Blackjack 24 RTR Radio Tray Addendum

November 18, 2014

Products: PRB Blackjack 24™ (PRB08007)

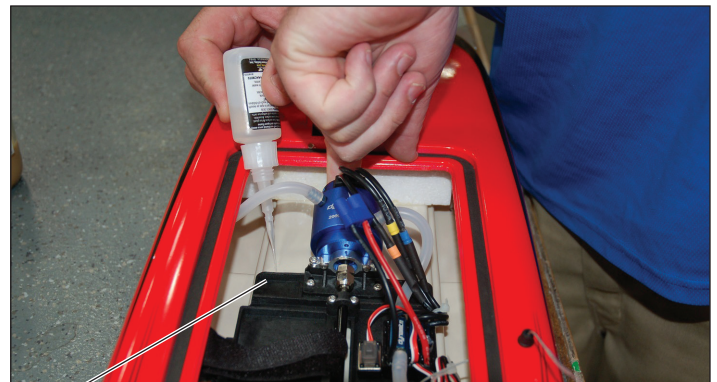
Issue: Some boats may have loose radio trays.

1. Pulling on the battery straps may loosen the radio tray from the hull.
2. If the radio tray becomes loose, apply CA (cyanoacrylate adhesive) between the tray and the hull as shown in these photos.

What to Do: Inspected radio trays are marked with a green dot as shown in this photo and are correct. If there is no inspection mark, check to make sure the radio tray is firmly attached to the hull.
Contact Horizon Hobby Product Support if you have any questions.

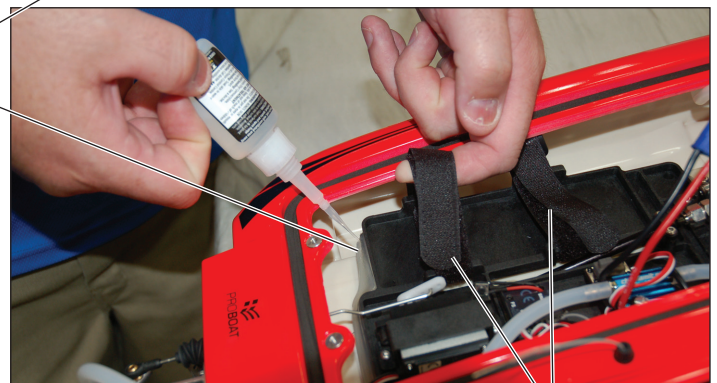
IMPORTANT: The motor is connected to the shaft, holding the tray in the hull. Carefully lift the tray while applying adhesive.

Carefully lift the radio tray up and apply CA between the tray and Hull
